EA Engineering, Science, & Technology, Inc., PBC
320 Gold Avenue SW, Suite 1300
Albuquerque, New Mexico 87102

July 13, 2021

**RE: S2AP ADDENDUM FOR REUSE OF PUMPED GROUNDWATER, REVISION 02
DEL ORO DAIRY, ANTHONY, NEW MEXICO**

DOÑA ANA DAIRIES MESQUITE, NEW MEXICO			
PROPOSED EXTRACTION SYSTEM AT DEL ORO DAIRY SOUTHERN PORTION, PERCHED AQUIFER			
	PROJECT No. 1464105.01		SCALE AS SHOWN
	DESIGN NA	RM	
	GIS RM		
	CHECK		
REVIEW			FIGURE 1

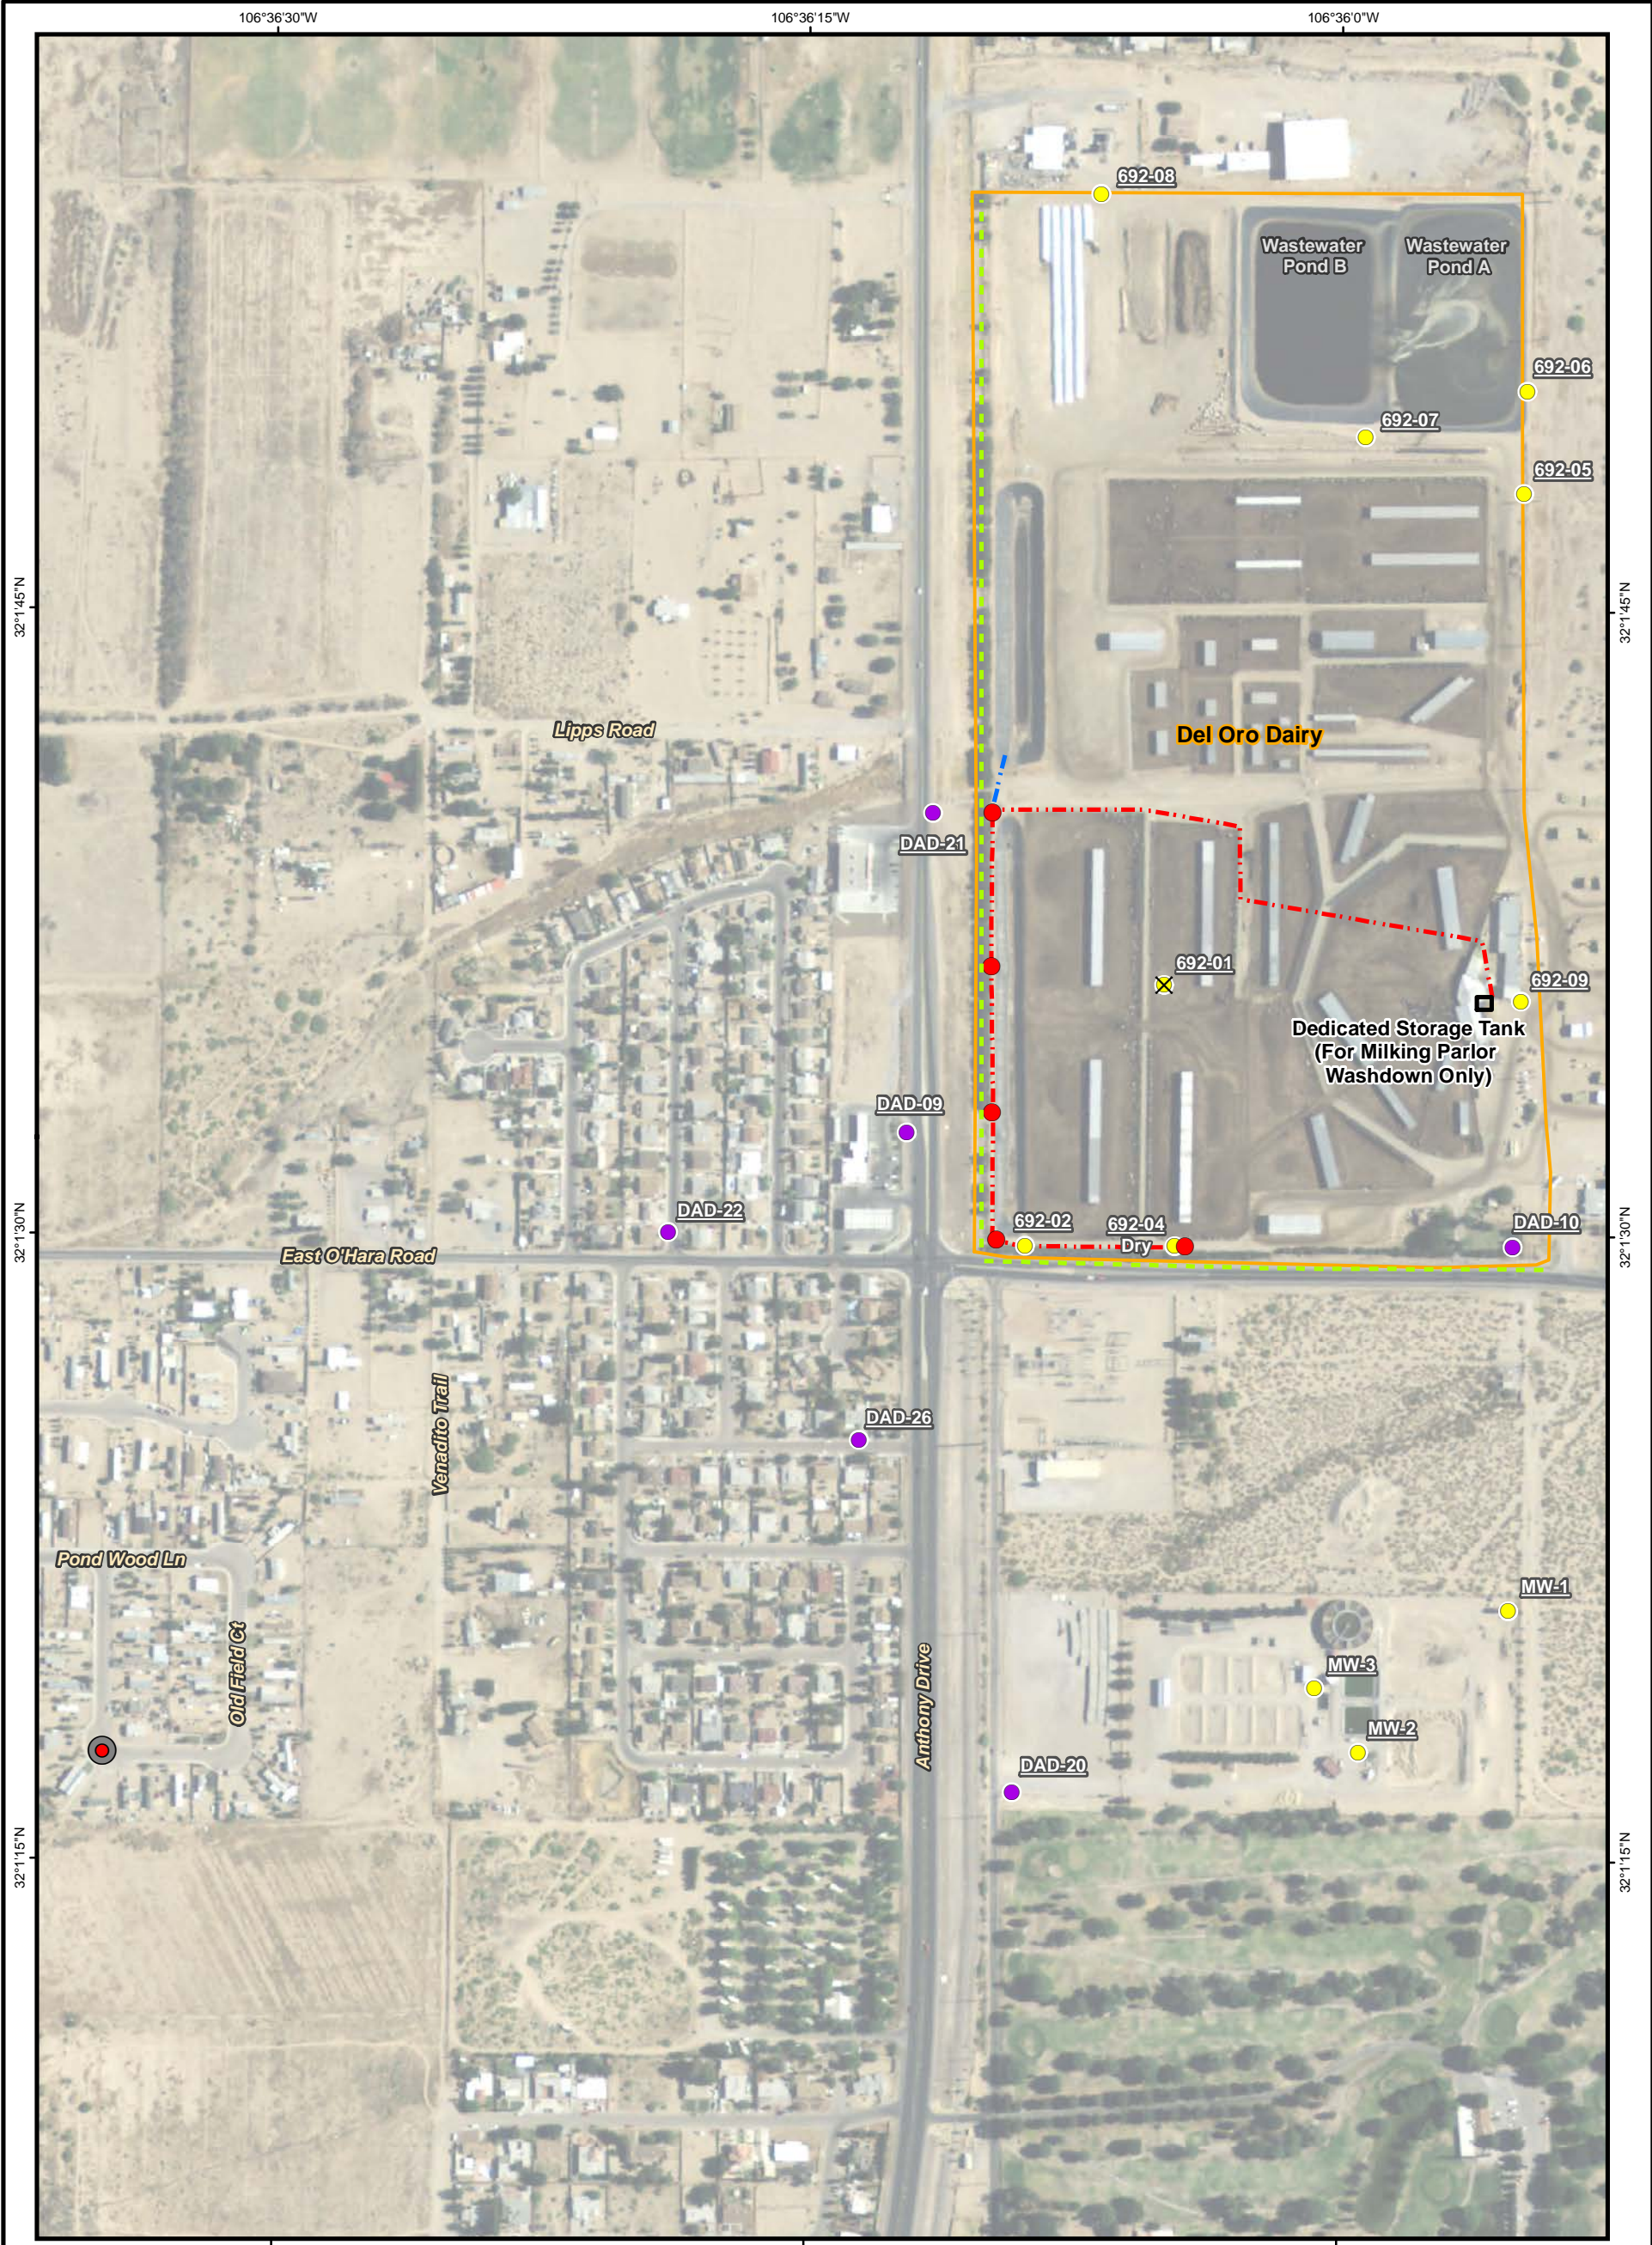
A capture analysis will be performed within 60 days of extraction well network installation to verify that the plume is fully captured by the five extraction wells that will be installed along the downgradient perimeter of the Del Oro Dairy property. If an extraction well becomes inoperable, notification will be provided to NMED within 24 hours of its discovery. It is anticipated that if one

pumping well becomes inoperable, the remaining four wells will be adequate to capture the plume. If the capture analysis shows otherwise, a separate contingency plan will be developed and submitted to NMED.
